**Rezoning Transportation Analysis**  
**Petition Number: Insert Zoning Petition #2021-213**  
*General Location Identifier: 22706130*

Revision Log:	Date	Revision Log:
	01/21/2022	First Review (WB)
	02/21/2022	Second Review (WB)

**General Review Information**

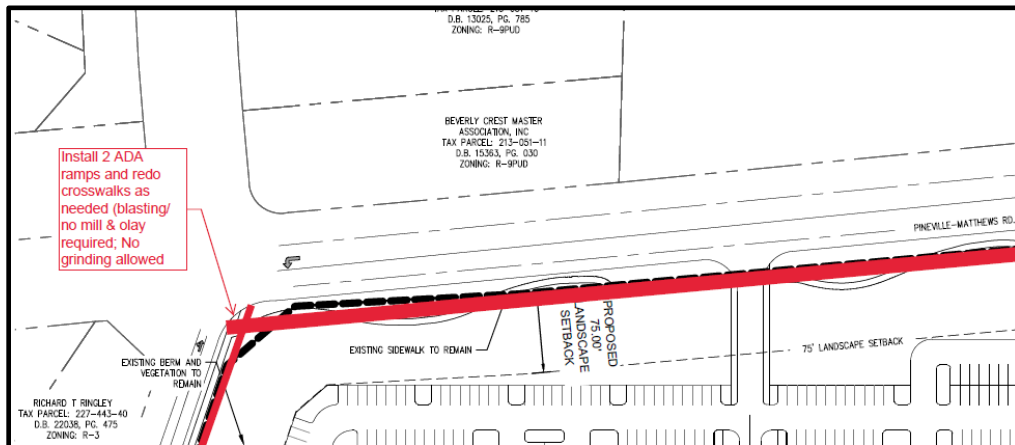
A Traffic Technical Memorandum (TTM) is necessary for the complete review of this petition due to the site being in a high congestion area and additional site traffic utilizing the traffic signal at Pineville-Matthews Road and Echo Forest Drive.

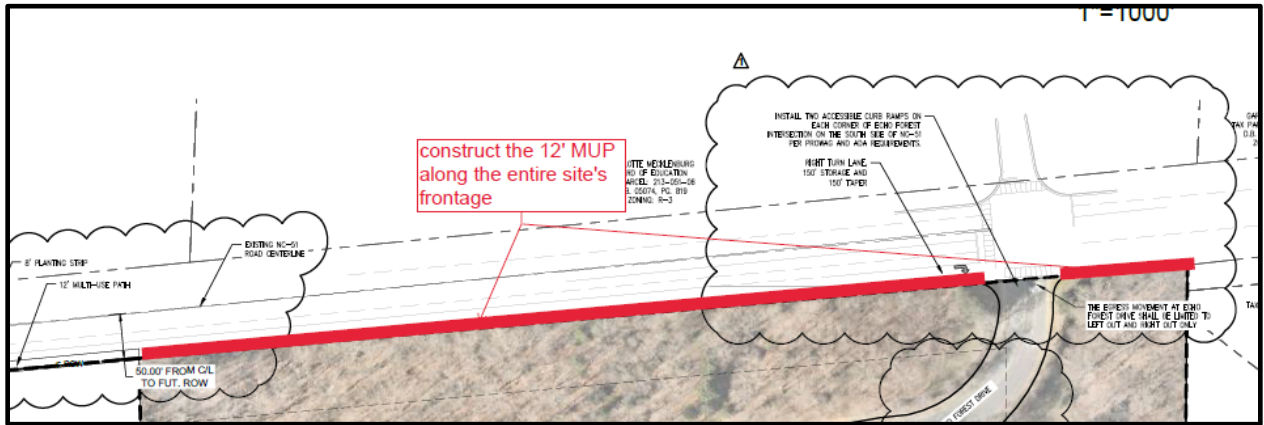
5. **Comment Clarification** (Site plan reviewed on 2/21/22): Site plan and conditional notes revisions are needed to commit to construct bicycle facilities by installing a 12-foot multi-use path along the site's entire Pineville-Matthews Road frontage in accordance with the Charlotte BIKES Policy. The site's frontage includes both Area's A and B.

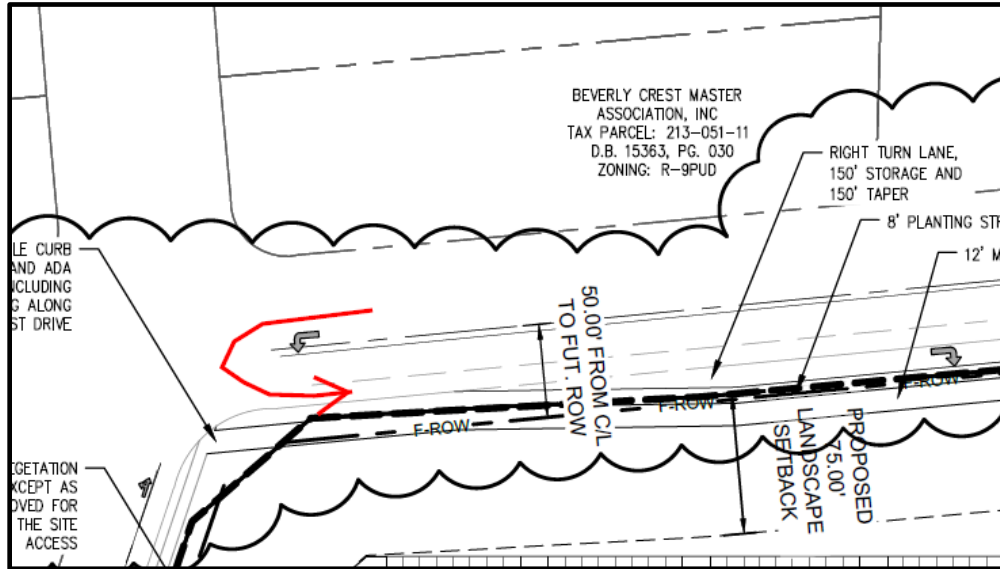
12. **New Comment** (added on 2/21/22 to address traffic concerns): Petitioner to provide passenger car and truck turning movements for U-turns movements made on Pineville-Matthews Road at the Hugh Forest Road intersection.

**New Comment** (based on site plan reviewed on 2/21/22):

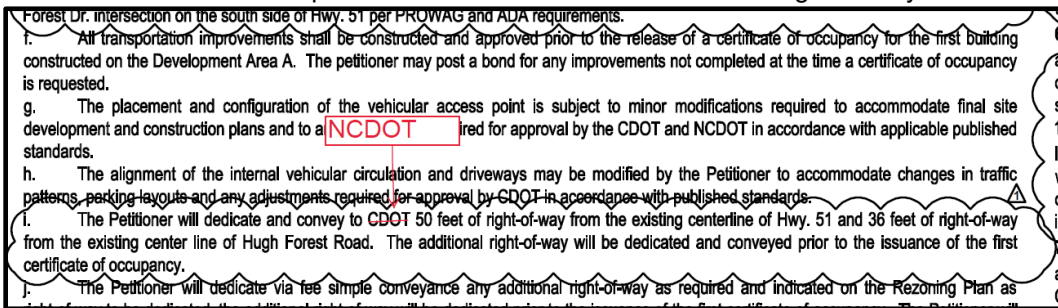
Correct Conditional Transportation Note 3.i to dedicate 50-foot of right-of-way to NCDOT.
